March 11, 2024

RE: Comments of the National Lime Association on: Supplemental Notice of Proposed Rulemaking: National Emission Standards for Hazardous Air Pollutants: Lime Manufacturing Plants Amendments, Docket ID No. EPA-HQ-OAR-2017-0015, RIN 2060-AV59

Figure 1 – Illustration of the Shapiro -Wilk Test Results and Corresponding P-values

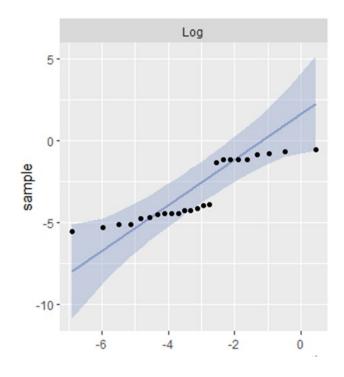
Although this methodology is not supported by precedent in EPA's extensive history of setting MACT limits, NLA has reviewed this data set using this test. As shown in graph below, the data set using this new test is not normally distributed because a small subset of values lie slightly outside of the p-value allowable range. The outcome is that EPA's proposed limitation is substantially and unreasonably lowered.

In the figure, the limited data points outside the blue shaded areas force the conservative conclusion from the Shapiro-Wilk test that the dataset is "skewed" contrary to EPA's conventional normality tests for setting UPLs.
